Supplemental Material
For
City of Sacramento
Design Commission
Agenda Packet

Project Name: 24th & T Street Residences (P10-089)

Correspondence enclosed that was submitted to staff on July 13, 2001. Three letters submitted by Danny Gomez: letter dated July 12, 2011; letter dated May 24, 2011; letter dated October 18, 2010. Only the July 12, 2011 letter is not found in the staff report.

Subject: Proposed Courtyard Apartments Project at 2331 "T" Street (24th & T)

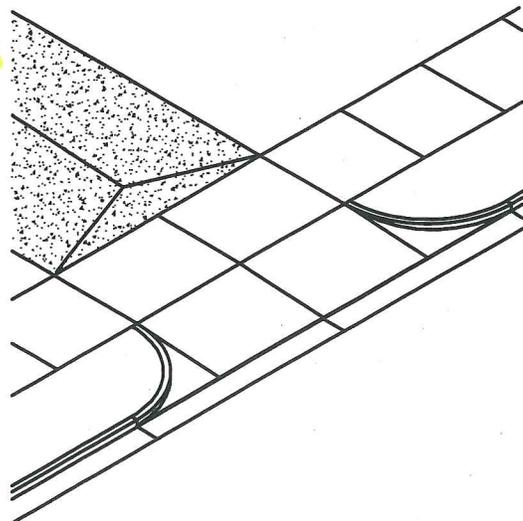
2. In the ***City of Sacramento's Design and Procedure Manual, Section 15 – Street Design Standards***, "15.6.10. Alley Maneuvering Areas cites the following: "...A 6 foot setback from the public right-of-way is required in order to ensure adequate maneuvering room is available." The attached diagram identified as PLATE 15-14 illustrates a 6 foot setback on each side of the 20 foot alley. Please clarify this as one of the proposed setbacks is on our property.
